<b>ITEM: 6.5</b>	<b>REPORT SUMMARY MINOR VARIANCE APPLICATION FILE NUMBER A028/24</b>
------------------	--

## MINOR VARIANCE APPLICATION FILE NUMBER A028/24

<b>CITY WARD #:</b>	4
<b>APPLICANT:</b>	Bitra Rezazedenbaghael & Mohammad Vakili Rad
<b>AGENT:</b>	None
<b>PROPERTY:</b>	5 Keatley Drive, Maple
<b>ZONING DESIGNATION:</b>	See below.
<b>VAUGHAN OFFICIAL PLAN (2010) DESIGNATION:</b>	Vaughan Official Plan 2010 ("VOP 2010"): "Low-Rise Residential" by Volume 2, Section 13.26 North West Corner of Bathurst Street and Major Mackenzie Drive.
<b>RELATED DEVELOPMENT APPLICATIONS:</b>	None
<b>PURPOSE OF APPLICATION:</b>	Relief from the Zoning By-law is being requested to permit a proposed gazebo in the rear yard and reduced front yard landscaping requirements.

**SITE PLAN**

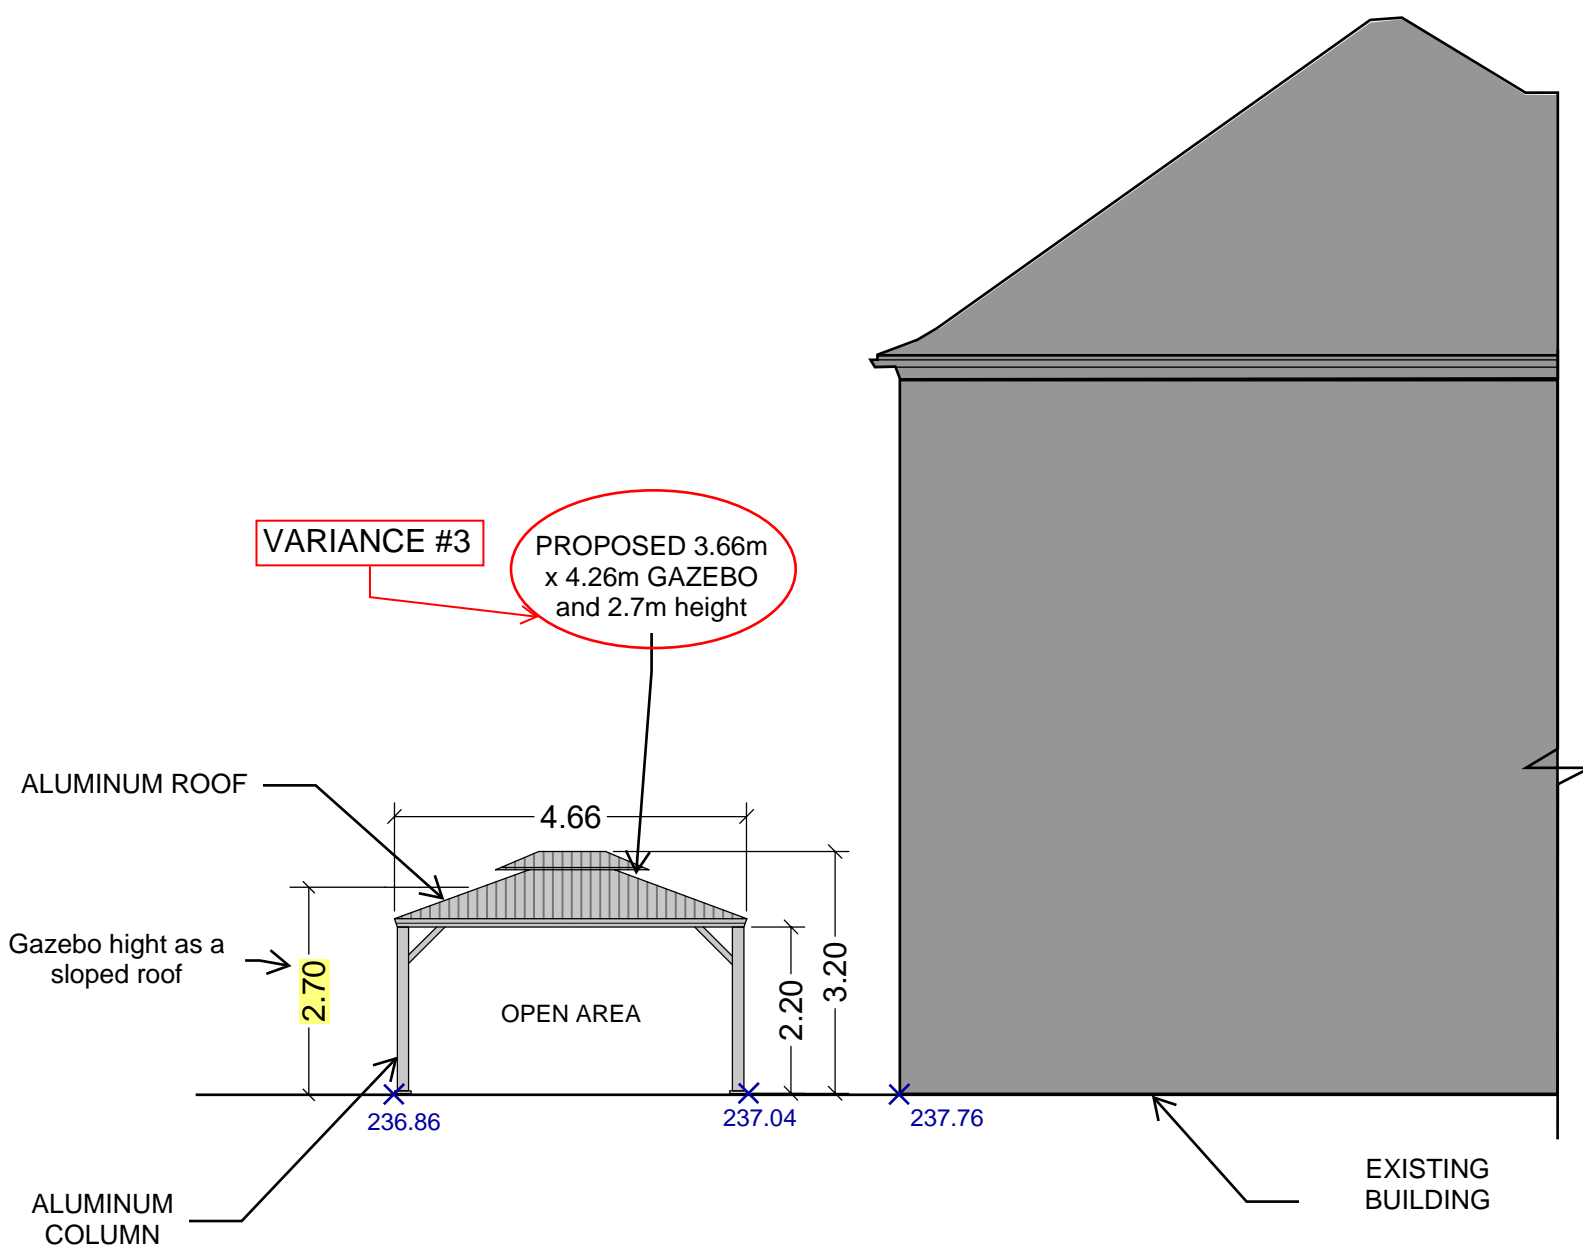
Development Planning Staff have conducted a review of the above-noted Minor Variance application. Staff would not be in a position to support the requested variance for the 6.8% soft landscaping in the front yard. We will require improvements made to the front yard and encourage you to consider placing grass along the easterly portion, and/or to install a much larger L-shaped planter in the front yard. Urban Design Staff have also reviewed the proposal and provided the attached comments.

Development Planning will require a substantial increase to the soft landscaping in the front yard. We will require something closer to 23.02sqm of soft landscaping for this site.

Development Planning will not be able to support the requested variance for the reduced soft landscaping in the front yard. Please advise if you intend on submitting revised plans to address these concerns.

I understand that you are choosing to proceed as is with your application. However as previously mentioned, Development Planning would not be able to support the reduced front yard soft landscaping. So, I am reaching out to you once more to see if you would be amendable to making some improvements. If changes are not made, Development Planning will be proceeding with a partial refusal report for this application.

I strongly encourage you to consider making some form of improvement such as a larger L-shaped planter, or some cedar planting/grass along the side of the driveway, we just cannot support the current 6.8% soft landscaping as it currently stands. If you are able to increase the percentage somewhat, Development Planning might be able to reconsider our position on this variance. However, we will need to see some attempt at improvement to the current proposal.

I understand that you are proposing grass along the new strip in-front of the front door area. Based on Urban Design considerations, we typically like to see a minimum width of 1.2 m for landscape strips, as this is the minimum requirement to support more substantial vegetation. A slightly wider strip of grass would be preferred in the updated design.

Furthermore, one small adjustment that can greatly improve your current design would be to add a connecting horizontal portion closer to the sidewalk, similar to the conditions found at neighbouring properties (#9 and #13 Keatley Dr.). This L-shape configuration would be a very desirable addition to your design, improve streetscaping, and help further increase the overall soft landscaping percentage. I understand you have concerns regarding the challenges with removing portions of the interlocking due to the brick pattern in place and the need to cut stones. However, I encourage you to consider that removing stones along the horizontal portion may actually be less onerous as stones would not be cut since they were laid in a horizontal pattern.

**On June 11, 2024, the applicant provided a revised plan increasing landscaping onsite. The revised plan has been sent to zoning to review to confirm required variance.**
